System Impact Assessment Report

Final Report

Project: Young Davidson Project CAA ID 2008-312
Applicant: Northgate Minerals Corporation

Date: September 30, 2009

Figure 1

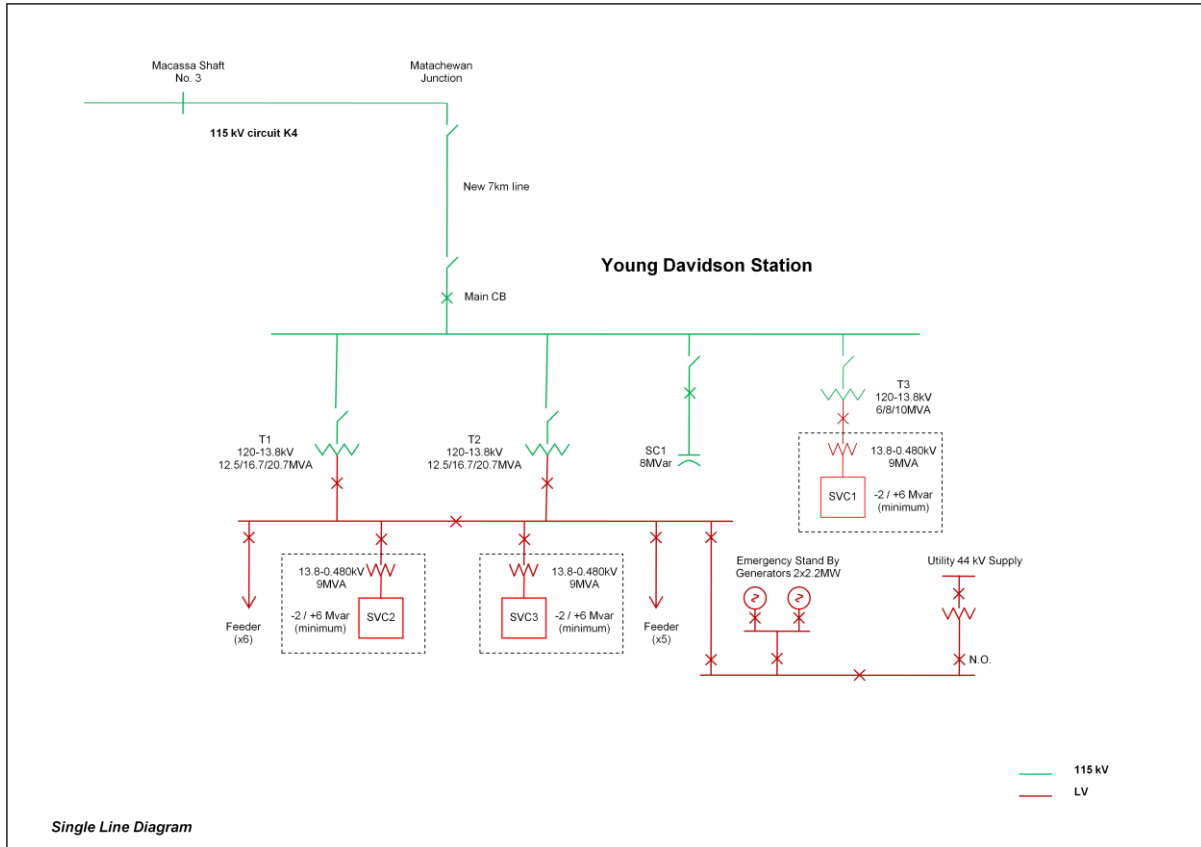
The simplified proposed connection arrangement of the Project is shown in Figure 1.

The proposed layout of the Project will not reduce the level of reliability of the integrated power system and is, therefore, acceptable to the IESO.
